MILLER CREEK ESTATES SUBDIVISION, REVISION TO THE RESUBDIVISION OF LOT 1

APPLICATION NUMBER 5 DATE July 21, 2011

APPLICANT Miller Creek Estates Subdivision, Revision to the Resubdivision of Lot 1

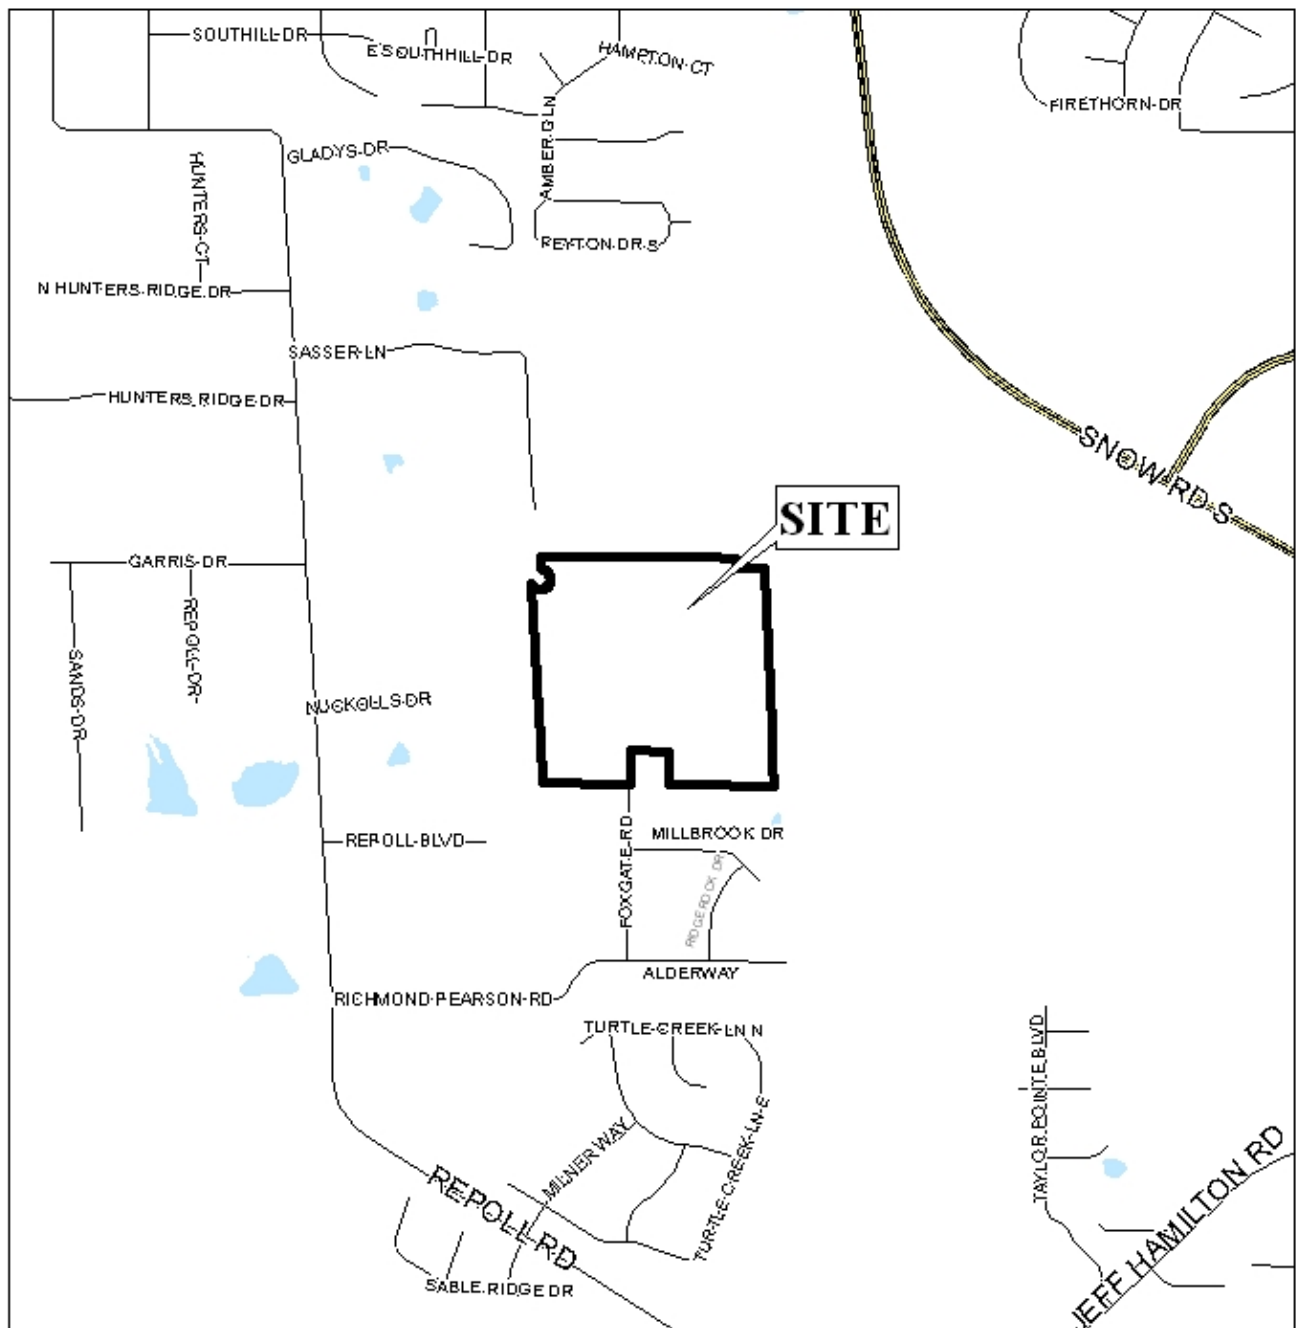
The proposed Lot 1-C meets the minimum size and frontage requirements as regulated by Section V.D.2. of the Subdivision Regulations. The proposed Lot 1-D is a flag lot, with 50 feet of public right-of-way frontage, and otherwise meets the size requirements of the Subdivision Regulations. The 25-foot minimum building setback line is depicted on the preliminary plat, and this should be retained on the Final Plat, if approved. The lot area sizes are depicted in acres, and this should be revised to include the size in square feet on the Final Plat, if approved.

The proposed lot 1-C fronts a 120-foot diameter cul-de-sac of Sasser Lane, an unpaved minor street not provided with curb and gutter, and the Northern terminus of Foxgate Road, a minor street provided with curb and gutter. Dedications were required in the original approval, as such, no further dedications should be required. Given the amount of frontage, both of the proposed lots should be limited to one curb cut with the size, design and location to be approved by Mobile County Engineering and conform to AASHTO standards.

Because this is a minor modification to an already approved subdivision, and does not involve creating any additional lots, approval, with the same conditions as the 2009 approval could be considered appropriate. The lot numbers should be changed to a nomenclature that is more distinctive, such as "Lot A" or "Lot 1."

This site is located in the County, thus any lots which are developed commercially and adjoin residentially developed property must provide a buffer, in compliance with Section V.A.8 of the Subdivision Regulations.

- 1) modification of the lot numbers to either "Lot A" and "Lot B" or "Lot 1" and Lot "2";
- 2) placement of a note on the Final Plat stating that each lot is limited to one curb-cut onto each street frontage, with the size, design and location to be approved by Mobile County Engineering and conform to AASHTO standards;

- 3) placement of a note on the Final Plat stating that no additional subdivision of either lot is allowed until additional frontage on a paved public street is provided, and no further subdivision of Lot 1-A is allowed that would increase the number of lots fronting onto Sasser Lane until such time it is paved in its entirety, and a paved cul-de-sac is provided;

- 4) retention of the 25-foot minimum building setback line as shown on the preliminary plat (The required setback should be depicted around any portion of Lot 1-A abutting a street-stub, and around that portion of Lot 1-B where the "pole" meets the "flag" portion of the lot.);

- 5) placement of the lot area sizes in square feet on the Final Plat;
- 6) placement of a note on the Final Plat stating that: *"Development must comply with the Mobile County Flood Damage Prevention Ordinance. Development shall be designed to comply with the storm water detention and drainage facility requirements of the City of Mobile storm water and flood control ordinances, and requiring submission of certification from a licensed engineer certifying that the design complies with the storm water detention and drainage facility requirements of the City of Mobile storm water and flood control ordinances prior to the issuance of any permits."*
